HARDWARE PATCH for Zemmix Neo, SX-1, SM-X and related machines (update 2020.04.06)

2020.08.19 Hardware Patch for OCM machines “aka BUSDIR_n patch”

THE FIX:

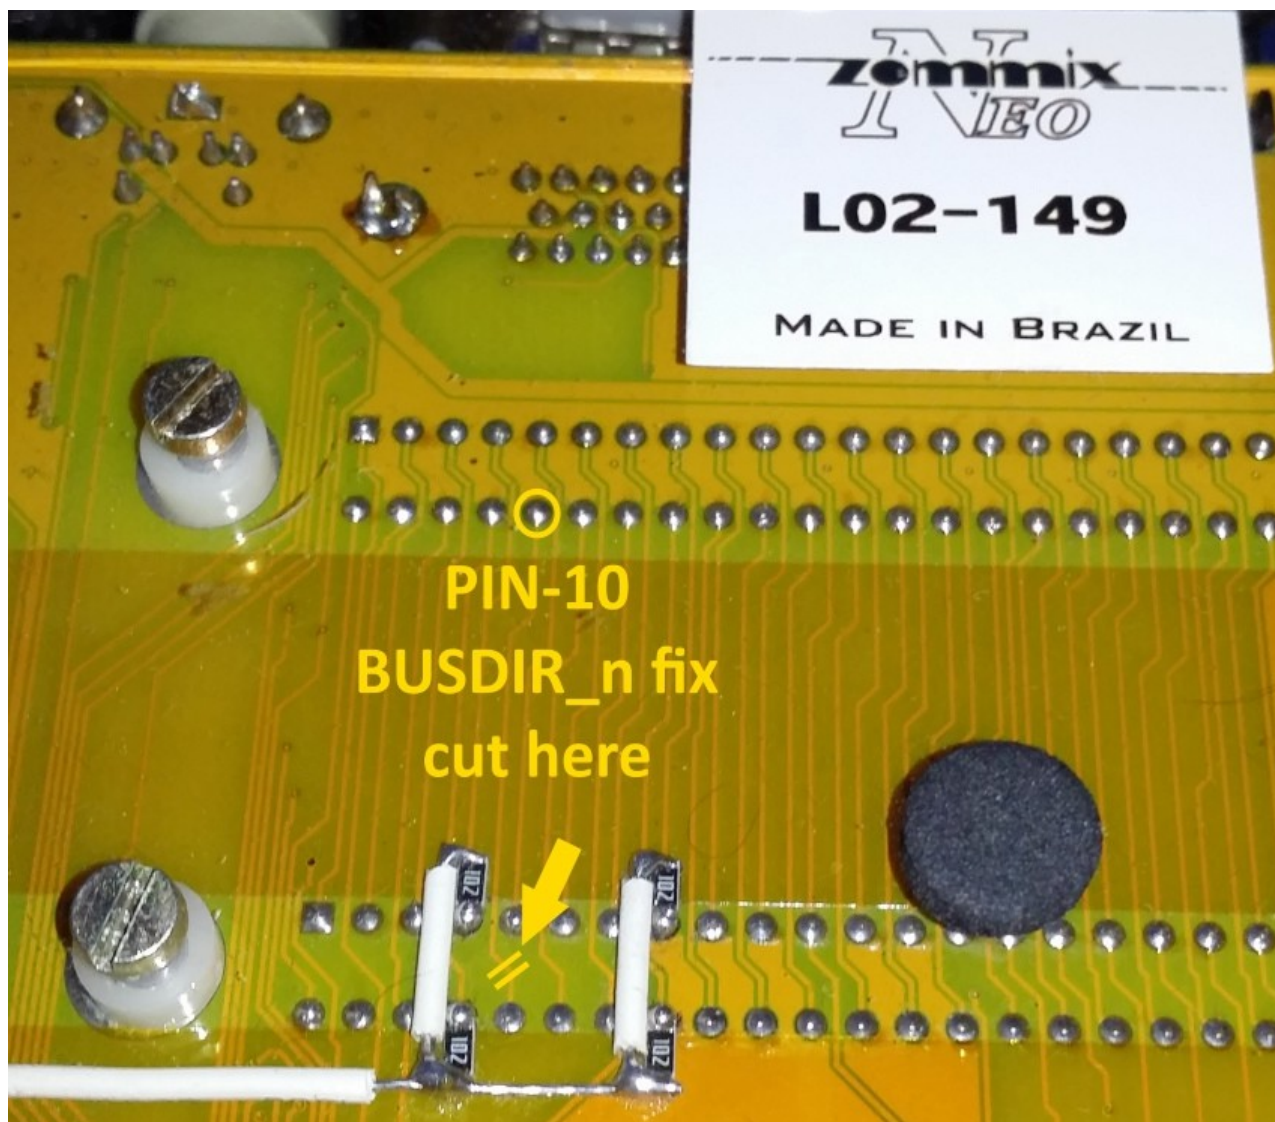
- In OCM machines we have a short circuit between pin-10 (BUSDIR_n) of the two external slots that continues towards the FPGA. This type of connection confuses some cartridges.
- While the Panasonic FS-A1ST and Canon V-20 service manuals confirmed that the BUSDIR signal is not used.

- Pin-10 (BUSDIR_n) of the external slots must be isolated.

- Method 1 - Cut the track that connects pin-10 of Slot-1 and Slot-2 leaving unchanged the connection to the FPGA already internally isolated by the firmware.
- Method 2 - Desolder pin-10 of slot-2 from the PCB and insulate it with the sheath of an electric wire and a drop of hot glue.
- Method 3 - Place non conducting tape over pin 10 of those cartridges that are not working properly, such as MoonSound and Darky.

2020.10.16 Hardware patch for Zemmix Neo BR machines (aka +5V line stability fix)

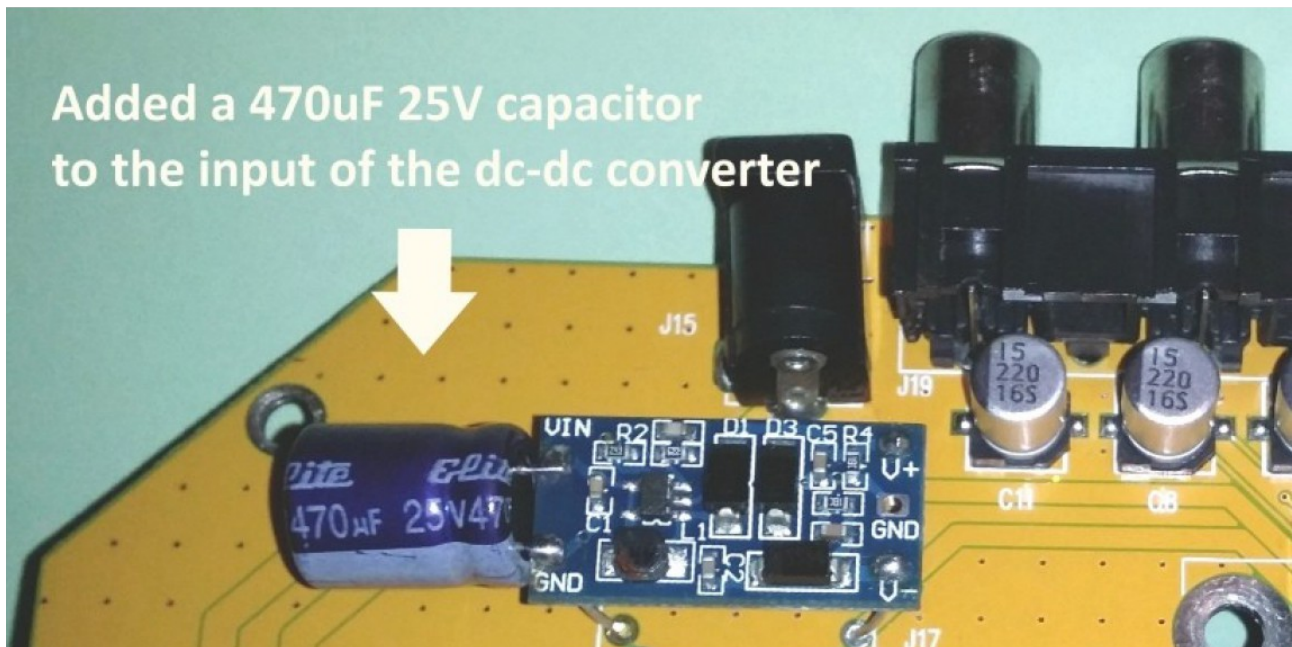
Based on the wiring diagram of the original 1chipMSX machine, I have implemented this new hardware patch for Zemmix Neo Brazilian which allows to stabilize the +5V input line. This patch can for example remove some annoying video interference on the output of GFX9000 and other similar cartridges. Please be informed that the problem is currently only present on Zemmix Neo Brazilian and not with Zemmix Neo Korean, but this fix can still be used if your hardware is unstable.

(aka PS/2 keyboard compatibility fix) [Revision 2]

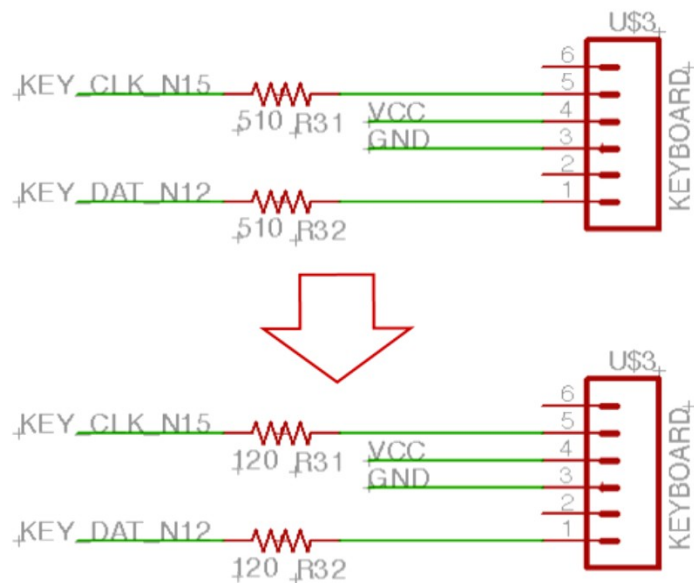
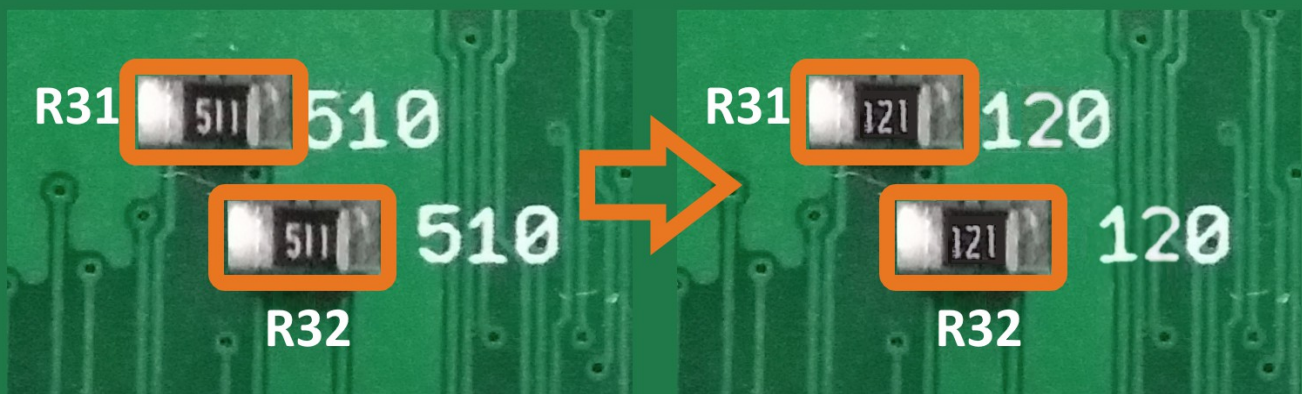
This is an optional fix. If your keyboard is NOT working properly you can apply this hardware patch or purchase another keyboard.

How to do it: replace the resistors
R31 and R32 with a value between 120 Ω and 390 Ω .
A value of 120 Ω is recommended to ensure maximum compatibility.
